**City of Surrey  
PLANNING & DEVELOPMENT REPORT**

Application No.: 7920-0076-00

Planning Report Date: July 11, 2022

to permit the development of a 6-storey residential apartment building.

CLIENT NO.	SHEET NO.
	AC-4.01
PROJECT NO.	REV. NO.
14001

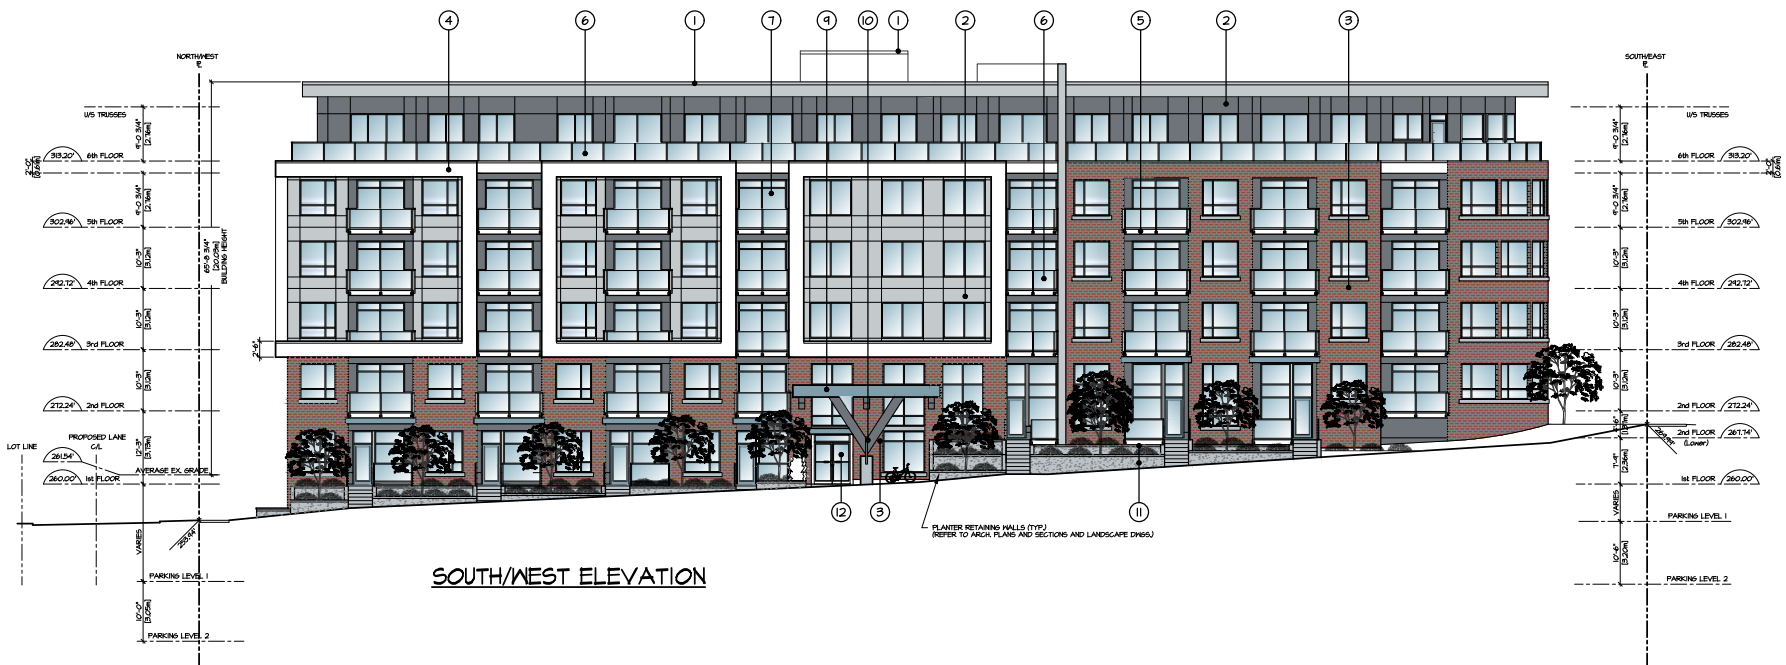
- Consider further design development of the southwest corner and south elevations such as rounding the corner, deleting the frame, or other design solutions. **The south and southwest corner has been revised as directed. The corner has been rounded, the roof overhang has been revised and the frame element has been eliminated.**

- Consider further development of the southwest roof overhang and recommend simplifying and differentiating the material. **The south and southwest corner has been revised as directed. The corner has been rounded, the roof overhang has been revised and the frame element has been eliminated.**
